STAFF REPORT
KETCHUM PLANNING AND ZONING COMMISSION
SPECIAL MEETING OF MAY 7, 2025

PROJECT: 120 N East Ave Addition

APPLICATION TYPE: Design Review (Application File No. P24-074)

REQUEST: Design Review for a proposed 2,270-square-foot addition to an existing commercial building

C1.00

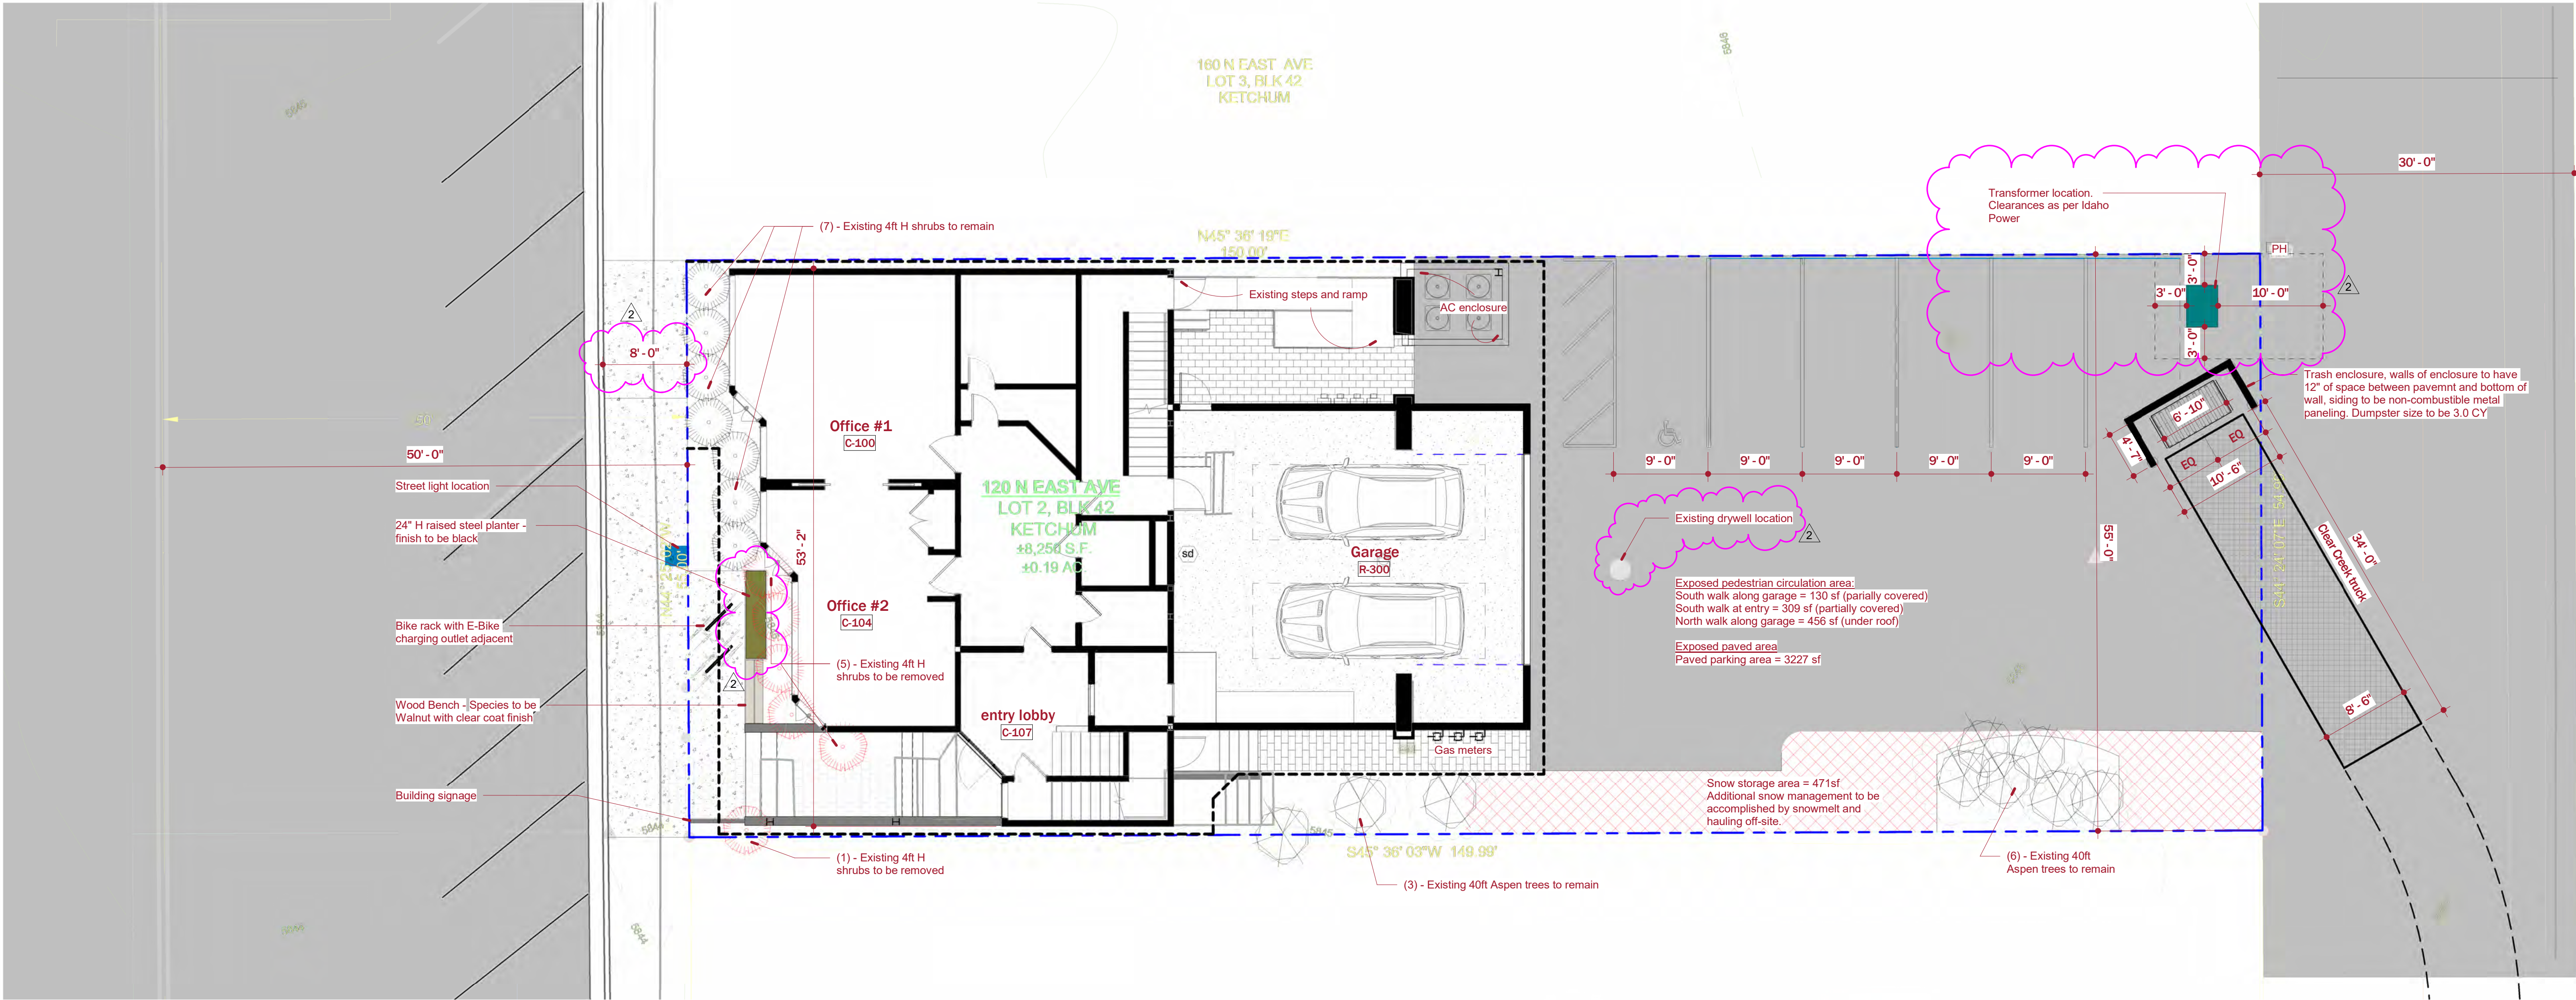
3. At time of building permit, the applicant shall submit final civil drawings prepared by an engineer registered in the State of Idaho that provide specifications for all right-of-way improvements, including sidewalks, alley asphalt, streetlights, utilities, and drainage facilities, for final review and approval by the City Engineer, Streets Department, Utilities Department, and Planning Department.

17.96.060.B.1 - Sidewalks	Conformance
<i>All projects under subsection 17.96.010.A of this chapter that qualify as a "substantial improvement" shall install sidewalks as required by the Public Works Department.</i>	YES
Finding: Ketchum Municipal Code 17.124.140 outlines the zone districts where sidewalks are required when substantial improvements are made, which include the CC, all tourist zone districts, and all light industrial districts. As the project is within the CC-2 zone district, sidewalks are required and included in the project plans. The applicant has proposed to install new 8-foot-wide sidewalk along 2 nd Street.

The applicant shall submit final civil drawings prepared by an engineer registered in the State of Idaho that provide specifications for all right-of-way improvements, including sidewalks, alley asphalt, streetlights, utilities, and drainage facilities, for review and approval by the City Engineer, Streets Department, Utilities Department, and Planning Department prior to issuance of a building permit for the project pursuant to condition of approval #4.

1 roof plan
A-104 1/4" = 1'-0"

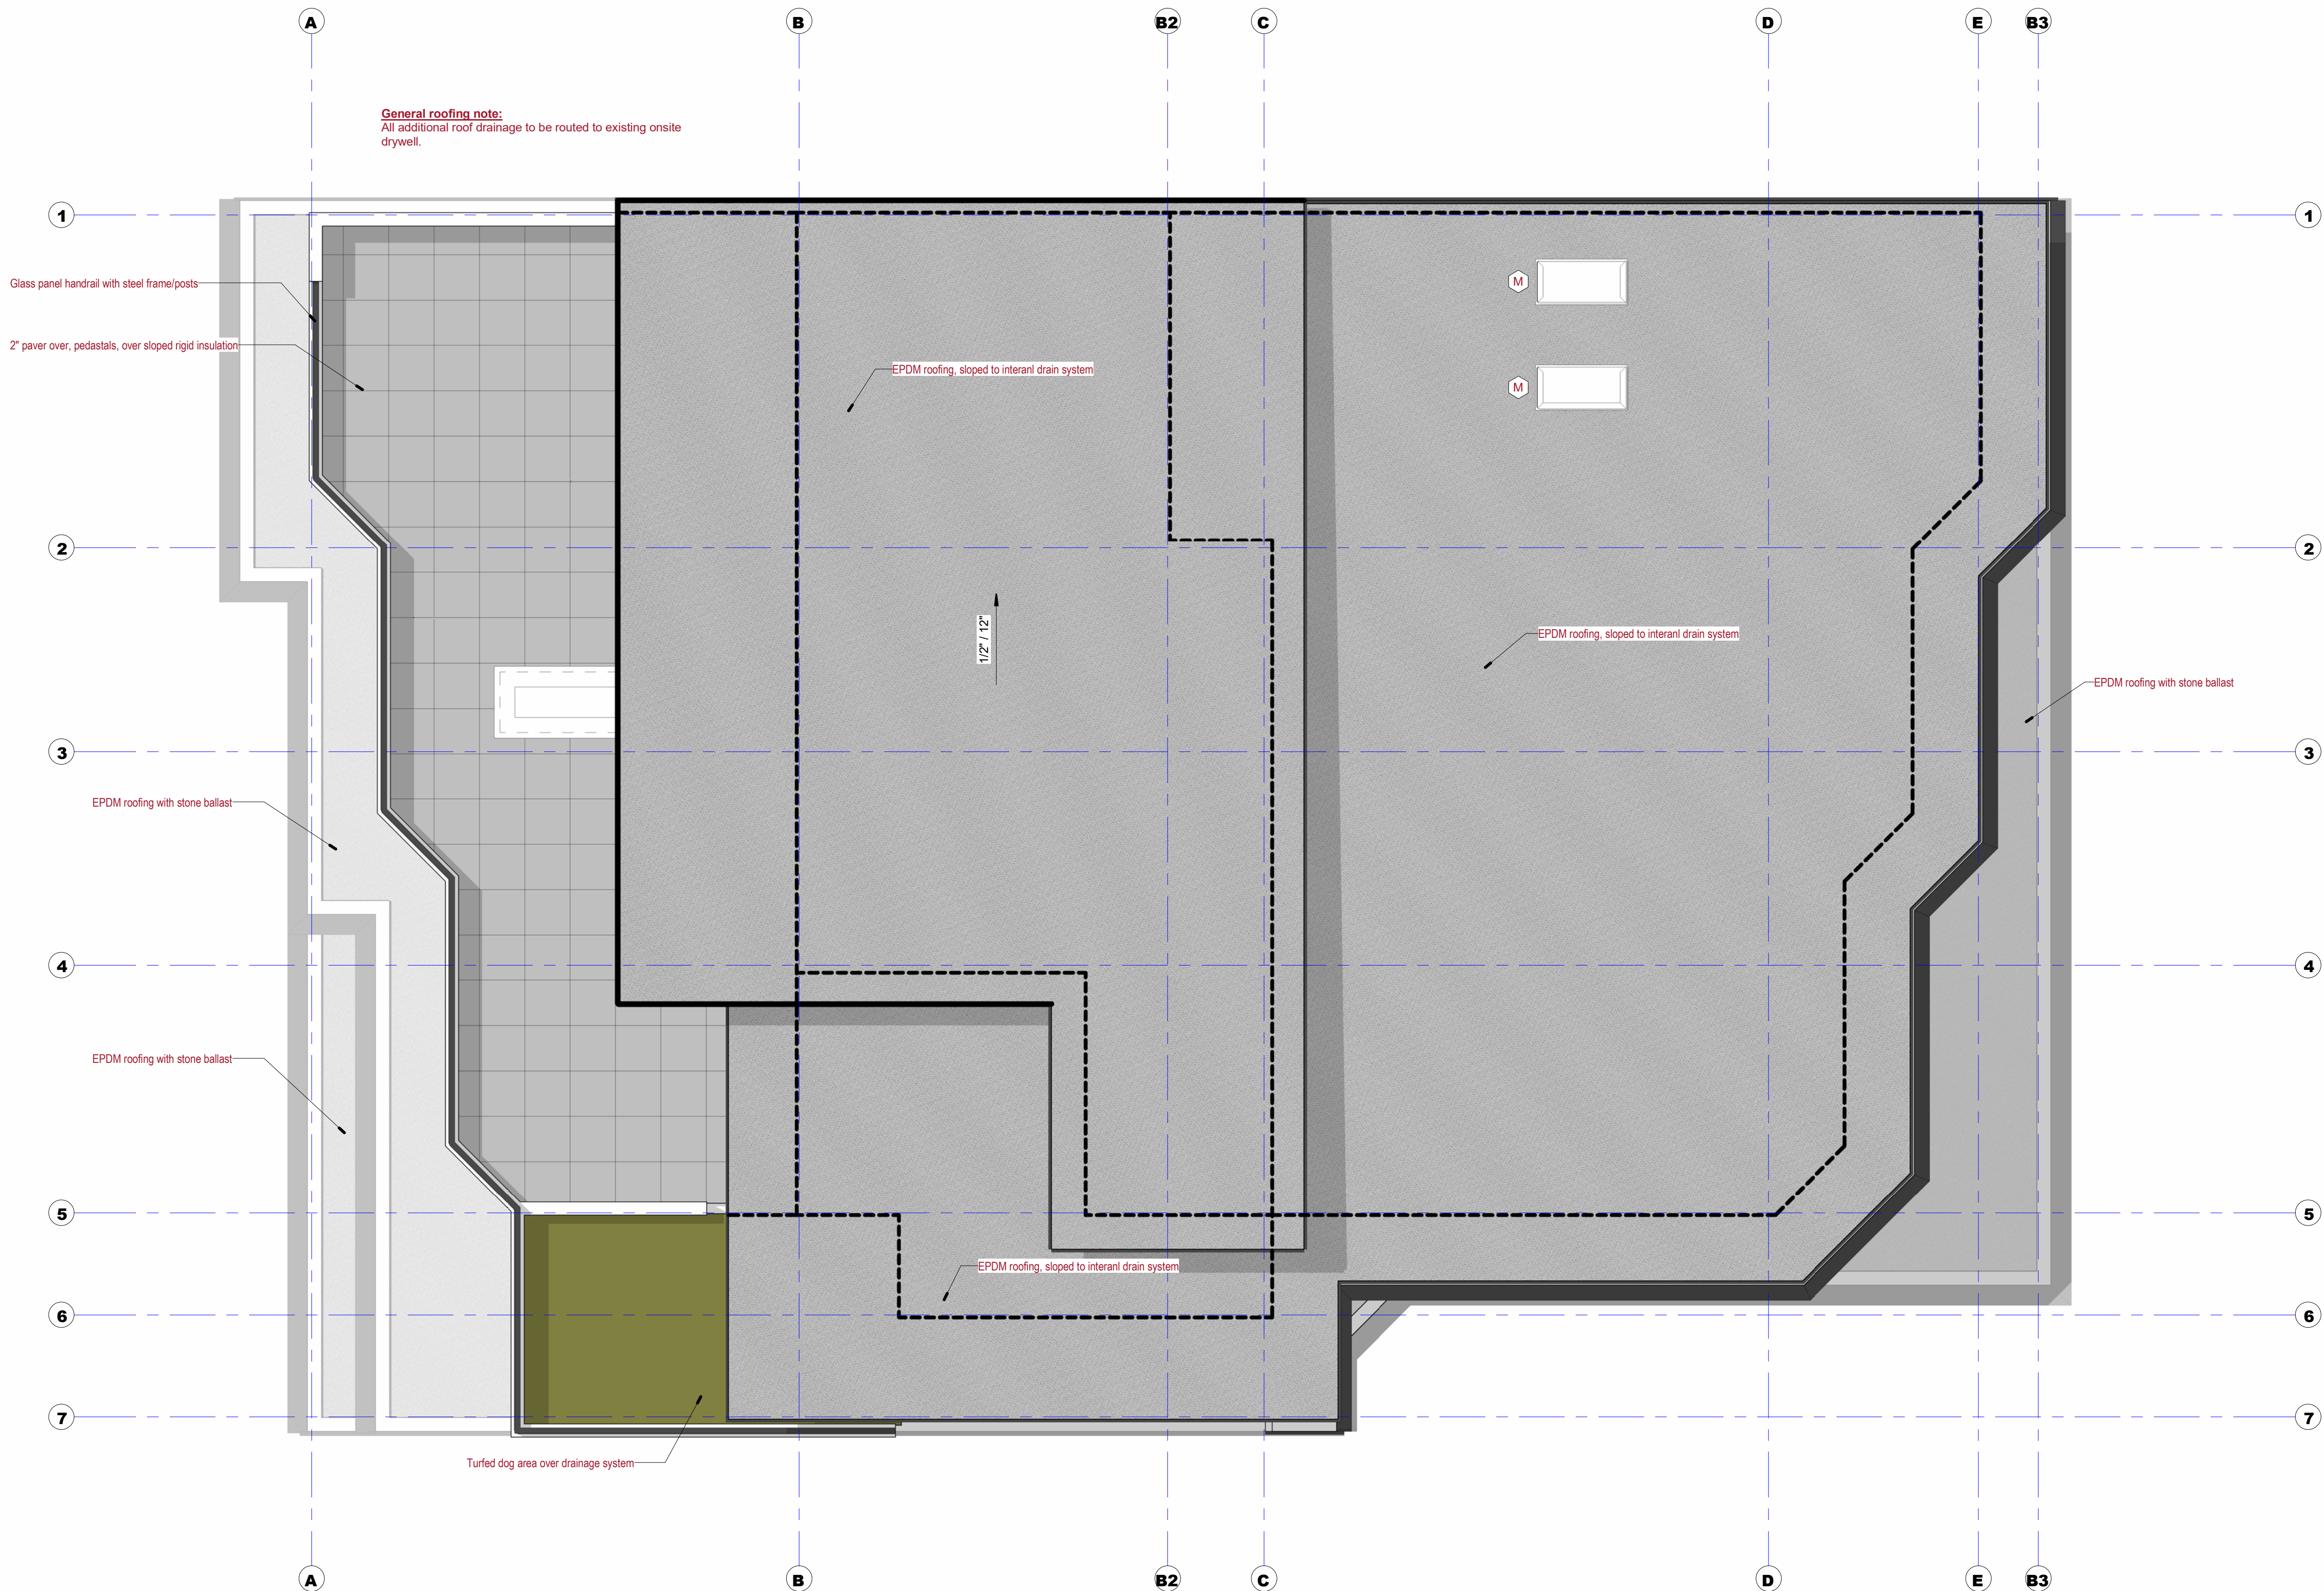
17.96.060.C.1 - Drainage	Conformance
<i>All stormwater shall be retained on site.</i>	YES Condition #4
<p>Finding: On-site stormwater drainage will be directed through internal roof drains to on-site drywells. The roof plan on revised sheet A-104 includes a note stating that the EDPM roofing will be sloped to an internal drain system. Specifications for the roof drainage submitted must be provided with the project plans submitted with the building permit application for final review and approval by the City Engineer.</p> <p>Pursuant to condition of approval #4, the applicant shall submit final civil drawings prepared by an engineer registered in the State of Idaho that provide specifications for all drainage improvements, for review and approval by the City Engineer and Streets Department prior to issuance of a building permit for the project.</p>

<i>All pitched roofs shall be designed to sufficiently hold all snow with snow clips, gutters, and downspouts.</i>	YES Condition #4
Finding: The roof plan on revised sheet A-104 includes a note stating that the EDPM roofing will be sloped to an internal drain system. Specifications for the roof drainage submitted must be provided with the project plans submitted with the building permit application for final review and approval by the City Engineer.
